VALVE ELECTRONIC

CV 2284

Specification CV2284
Issue 2, Dated 24. 7. 58.
To be read in conjunction with K1006
and with MIL-E-1/979C dated 18th June, 1957.

AMENDMENT NO. 1

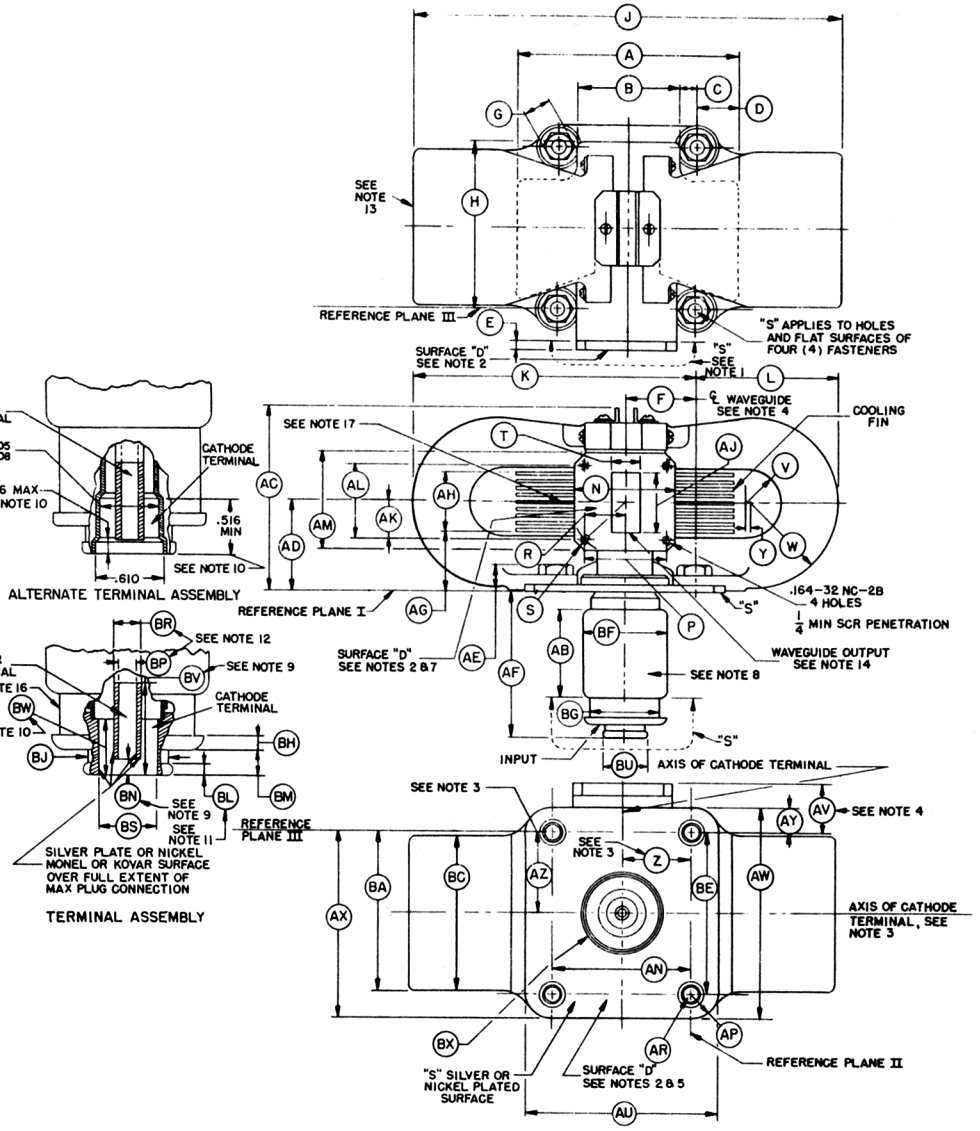
J.J. The diameter of the undimensioned collar on the cathode terminal shall not exceed 1.375 inches. (This can be found on the central projection and on the two left hand scrap views of the terminal and assemblies).

The external diameter of the cylinder which is integral with the output section shall be within the limits 1.790" - 1.835" for 0.6" behind the output flange, i.e. to a plane parallel to the front face of the output flange and 0.85" away. The actual diameter shall have a parallel tolerance of ± .005".
